**Addendum No. 1**  
 City of Coquitlam  
**RFP No. 26-031**

**Town Centre Park Service Hub Tenant Improvements**  
 Issue Date: April 16, 2026  
 Total Page Count: 5

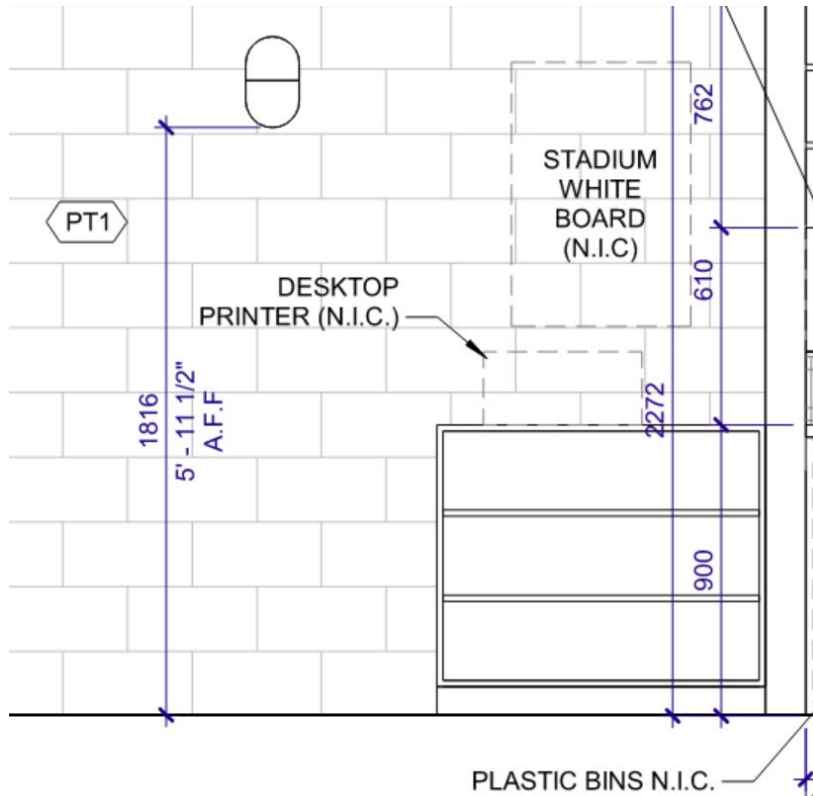
Q15. The specifications indicate new signage, but no details are shown on the drawings. Could you please confirm if this is within the scope of work?

**A15. Directional signage is not part of the Scope of Work.**
